TEDS EXCEPTION REQUEST

2712 Highway 50

Re: Design Exception #DE06-20- Corner Clearance and Access spacing 2712 Highway 50

DESIGN EXCEPTION #6-20

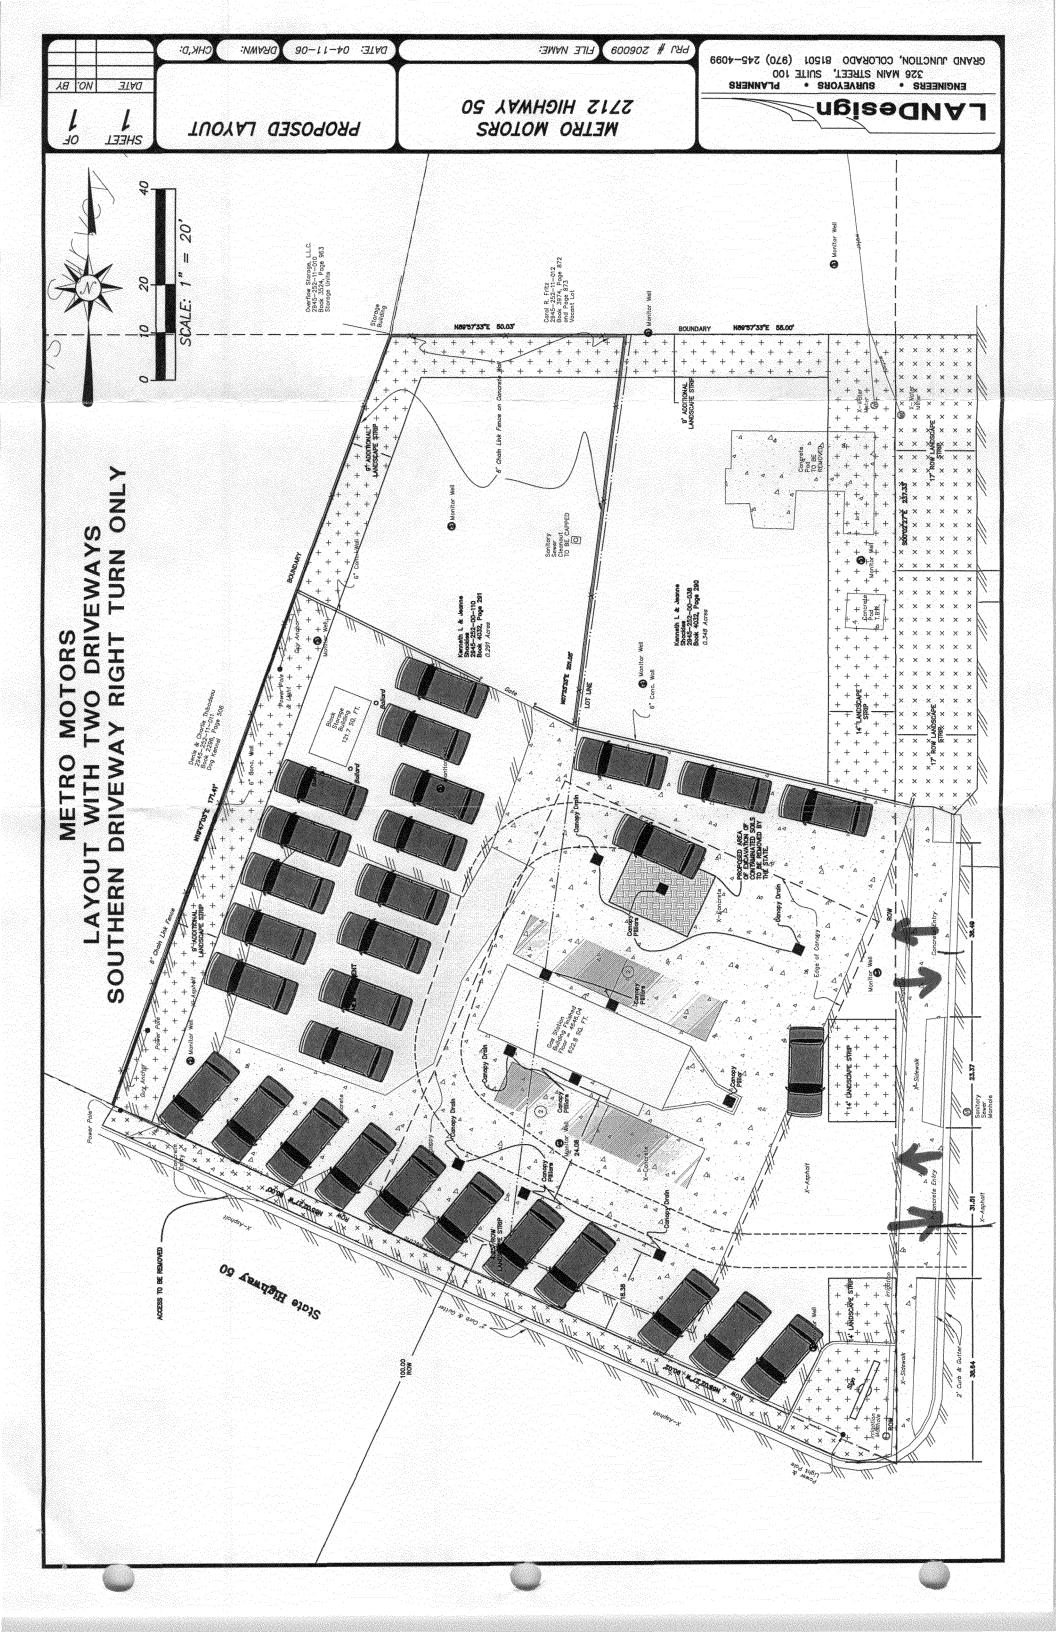
The problem with this site is that it was designed for flow-through traffic circulation. The existing building and canopy were designed with that in mind. The columns for the canopy are located in some very awkward places as far as traffic goes. If the access to Highway 50 is removed it becomes complicated to find a way to have customer traffic move through the site and park at the ideal locations (adjacent to the building). If it is a route, such as in Alternate 2, that is manageable by the average driver, but difficult, then it becomes a hazard for the poor or inexperienced driver.

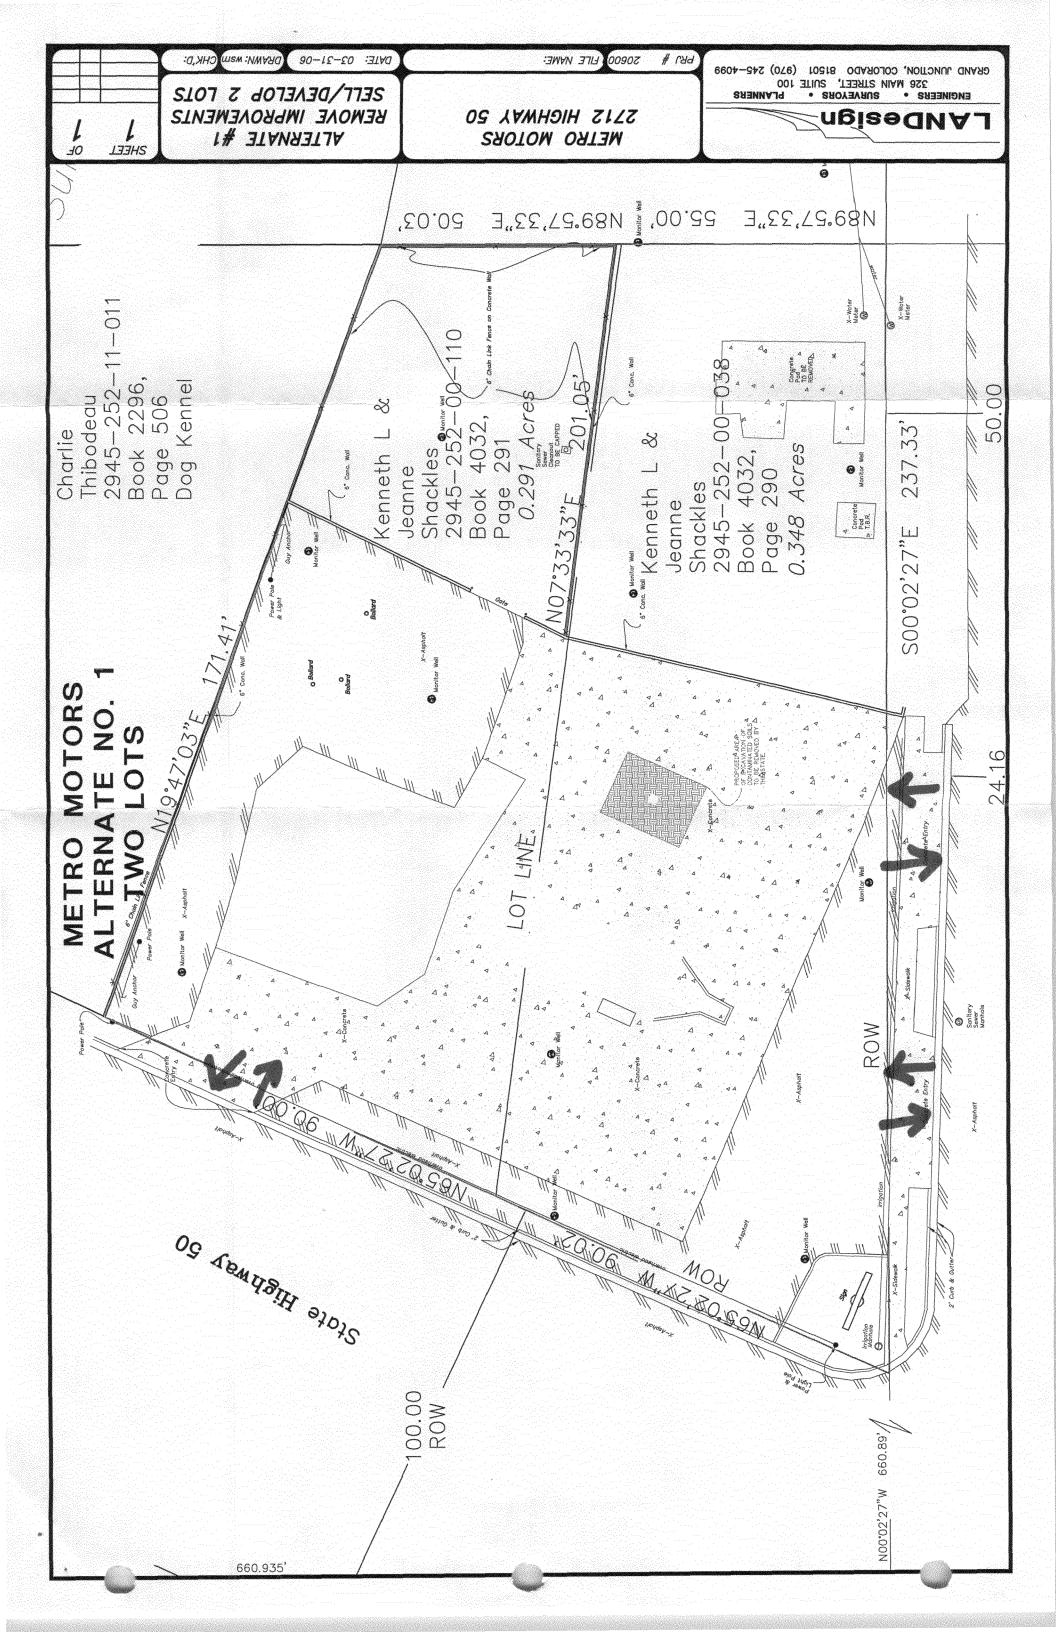
If the southern driveway is closed, and the dealer decides to not permit traffic circulation because of the hazards, then he has very large limitations on where he can have customer parking. The canopy columns are in a very poor location for arranging parking where the customers can pull in and back out.

Proposed Design

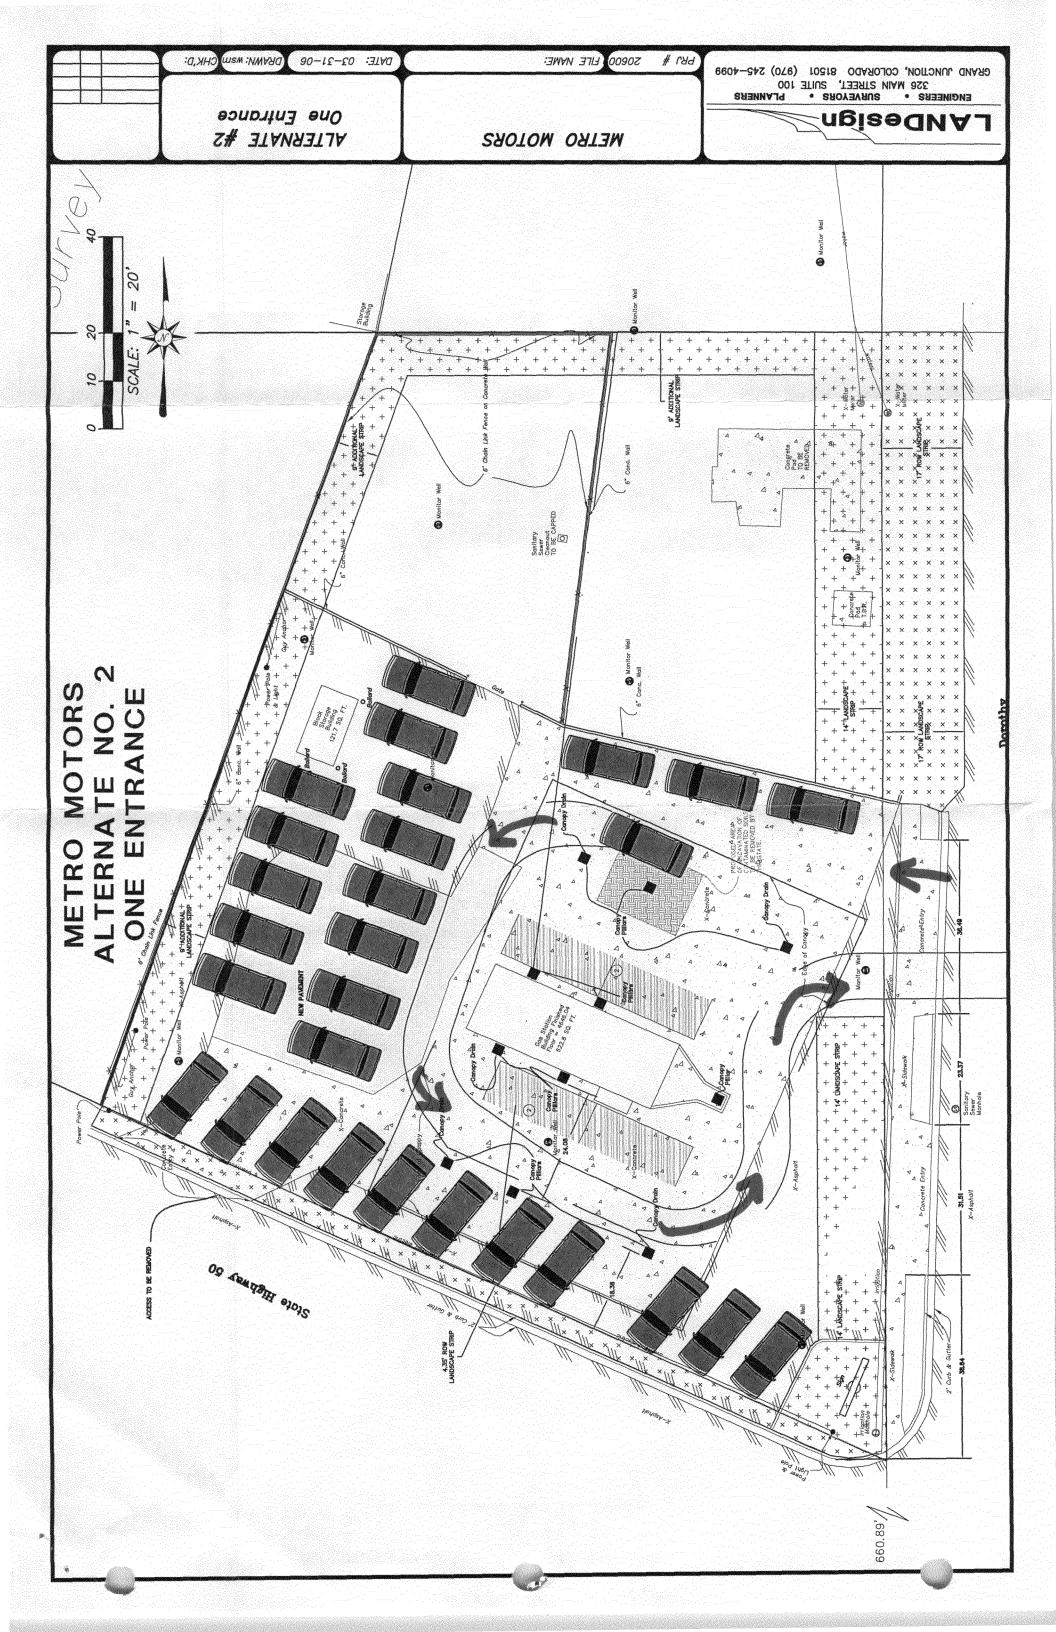
The proposed design is to leave both driveways on Dorothy Avenue in place. This will give the property owner the most flexibility in how he lays out his site, and will enable him to find the safest configuration.

Note: The committee agreed to allow a one-way in, one-way out configuration that will allow the use of both driveways on Dorothy Avenue.
